RE: **Texas Roadhouse**
10030 Coors Bypass Blvd NW
Grading and Drainage Plan
Engineers Stamp Date 11/5/15 (B13D014)

Based upon the information provided in your submittal received 11/16/2015, the above referenced Grading and Drainage Plan cannot be approved for Grading Permit or Building Permit until the following comments are addressed.

C4.0

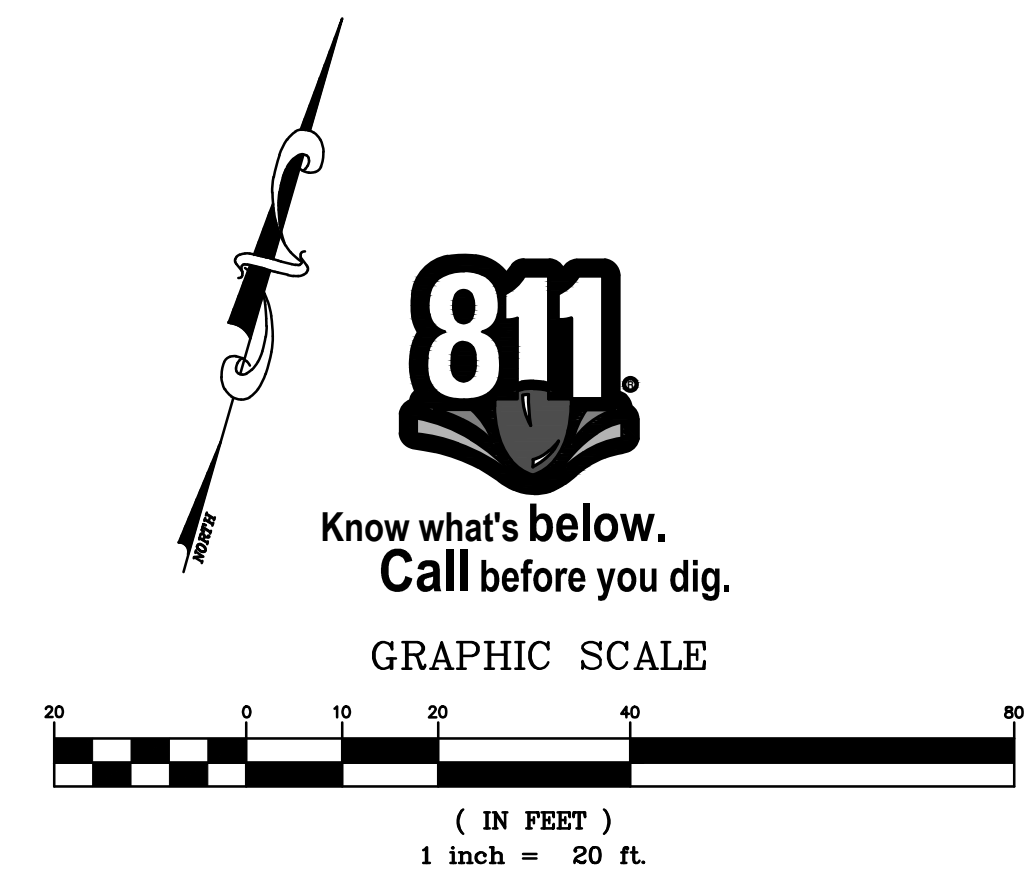
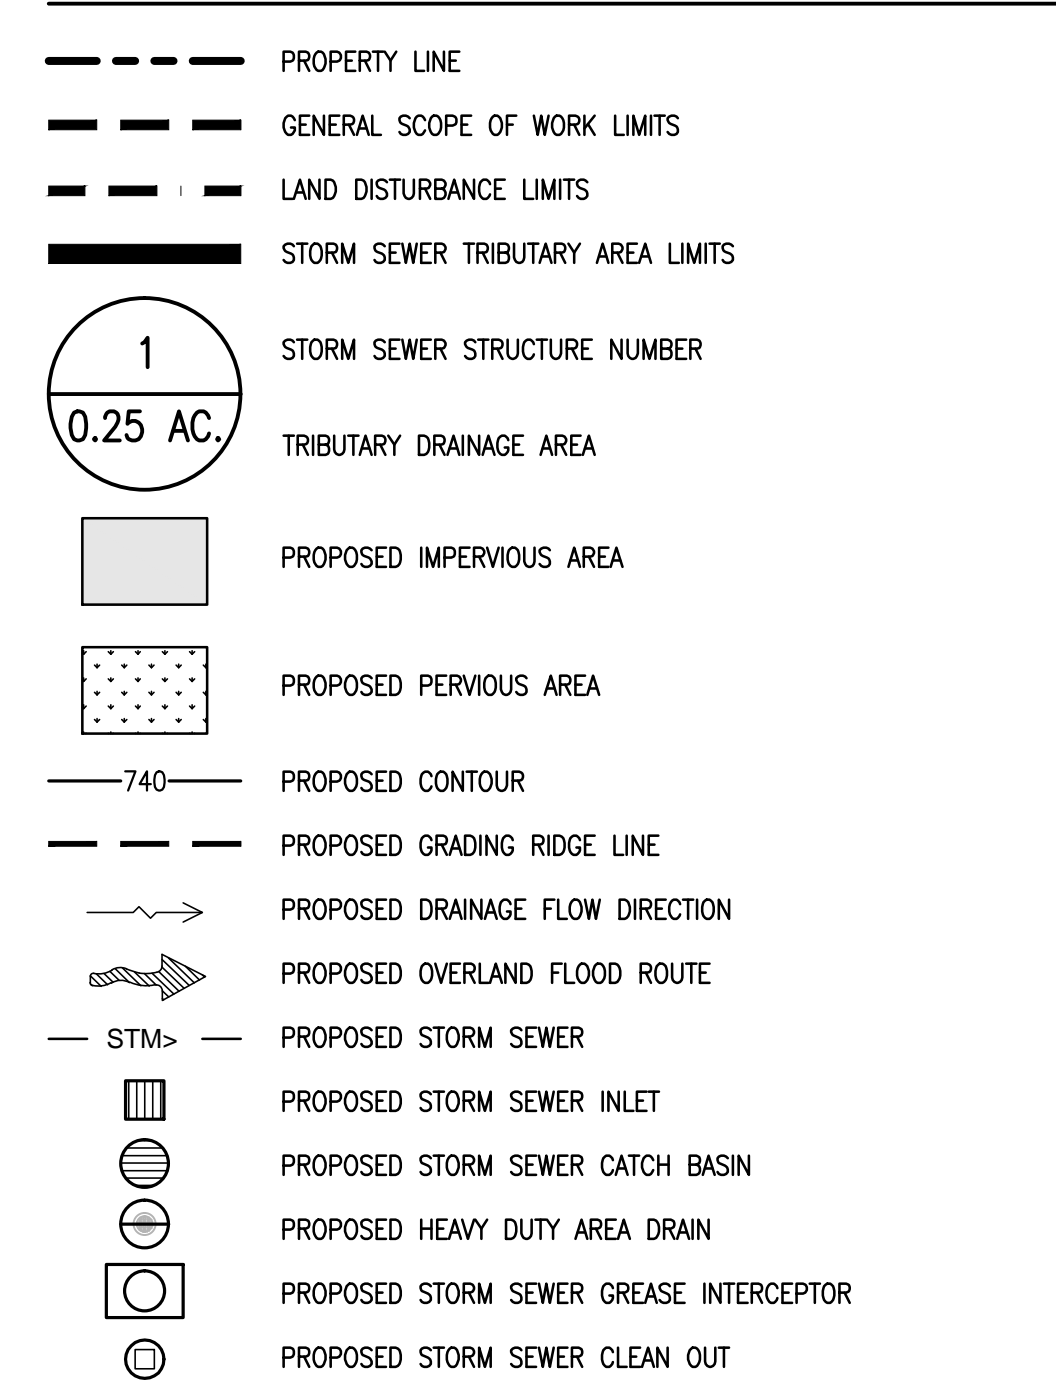
- All flows must run through a pond or swale before running into the storm sewer system. Remove the inlets in the parking areas. Daylight roof drains in the ponding areas. The areas west of the buildings can be graded as ponds with an elevated grate.
- The dumpster area must contain a drain connected to the SAS, with a grease trap.
- The south pond requires an emergency overflow.
- The northeast pond cannot be used for first flush volume if the bioswales bottom is set 18" below existing flowline (which would set the outfall for the pond at the pond's bottom).
- The elevation difference along the bioswale will make it difficult to contain 625cf of volume unless cutoff walls/terracing is called out.
- Pond volumes shown on sheet C4.2 do not match those displayed on sheet C101.
